SUBJECT: ORGANIZATION FOR CONDUCT OF PLANT OPERATIONS WHILE IN COLD SHUTDOWN
CONDITION (TAC NO. 65680)

RE: PEACH BOTTOM ATOMIC POWER STATION, UNIT NOS. 2 AND 3

AMENDMENT TO FACILITY OPERATING LICENSE

ATTACHMENT TO LICENSE AMENDMENT NO. 126

FIGURE 6.2-2
 ORGANIZATION FOR CONDUCT OF PLANT OPERATIONS
 PEACH BOTTOM ATOMIC POWER STATION

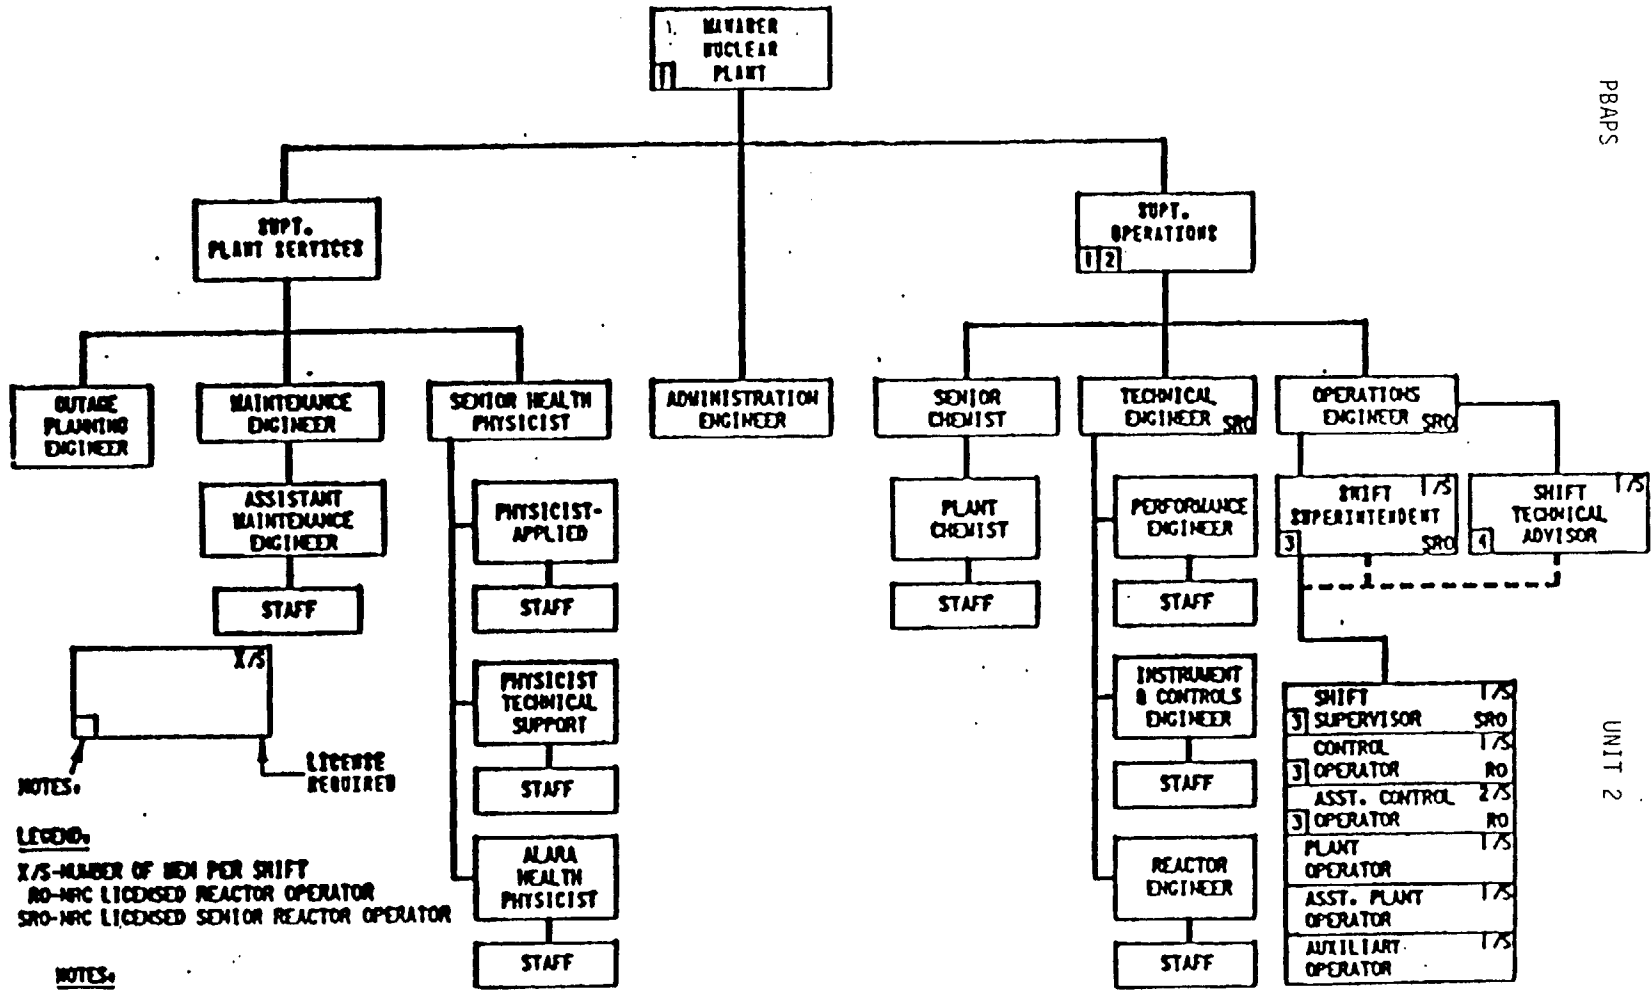
Replace the following page of the Appendix A Technical Specifications with the enclosed page. The revised area is indicated by marginal lines.

*Except during cold condition operations resulting from the NRC shutdown order of March 31, 1987.

- 1 EITHER PLANT MANAGER OR SUPT. OPERATION SHALL HOLD AN SRO LICENSE. *
- 2 ASSUMES DUTIES OF PLANT MANAGER IN HIS ABSENCE
- 3 ONE SRO & TWO RO PER SHIFT PERMITTED WHEN BOTH UNITS ARE IN THE SHUTDOWN OR REFUEL MODE
- 4 NOT APPLICABLE TO THE UNIT IN THE SHUTDOWN OR REFUEL MODE

FIGURE 6.2-2
ORGANIZATION FOR CONDUCT OF PLANT OPERATIONS
PEACH BOTTOM ATOMIC POWER STATION

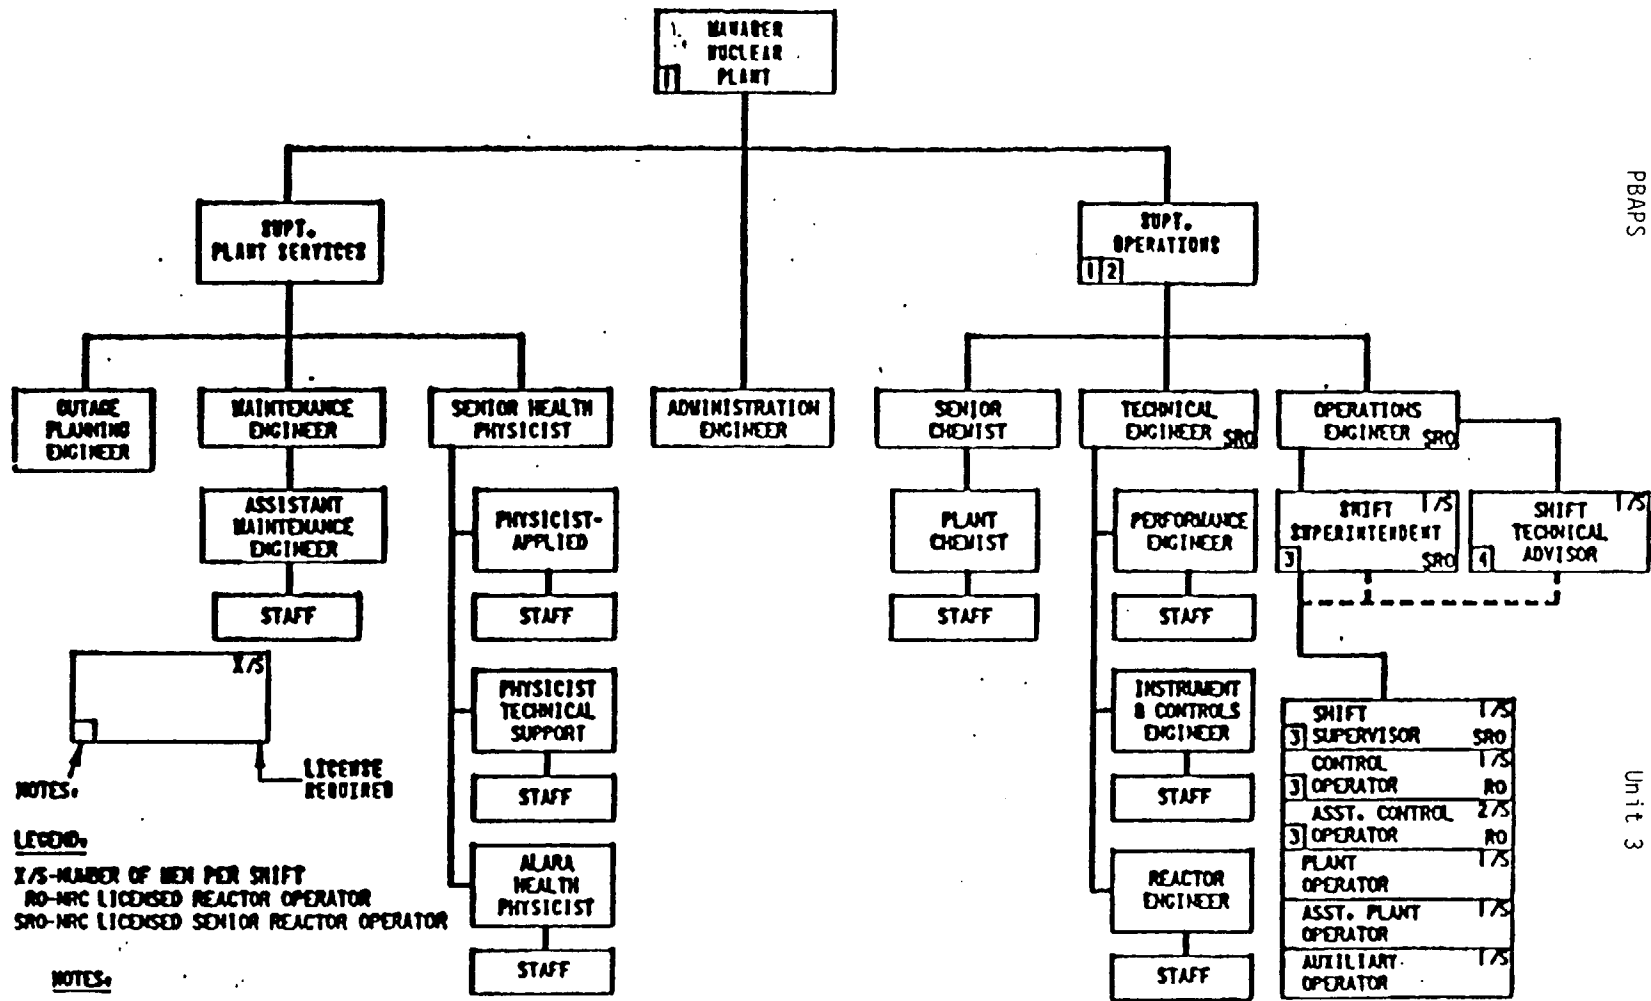
Replace the following page of the Appendix A Technical Specifications with the enclosed page. The revised area is indicated by marginal lines.

*Except during cold condition operations resulting from the NRC shutdown order of March 31, 1987.

- 1 EITHER PLANT MANAGER OR SUPT. OPERATION SHALL HOLD AN SRO LICENSE. *
- 2 ASSUMES DUTIES OF PLANT MANAGER IN HIS ABSENCE
- 3 ONE SRO & TWO RO PER SHIFT PERMITTED WHEN BOTH UNITS ARE IN THE SHUTDOWN OR REFUEL MODE
- 4 NOT APPLICABLE TO THE UNIT IN THE SHUTDOWN OR REFUEL MODE
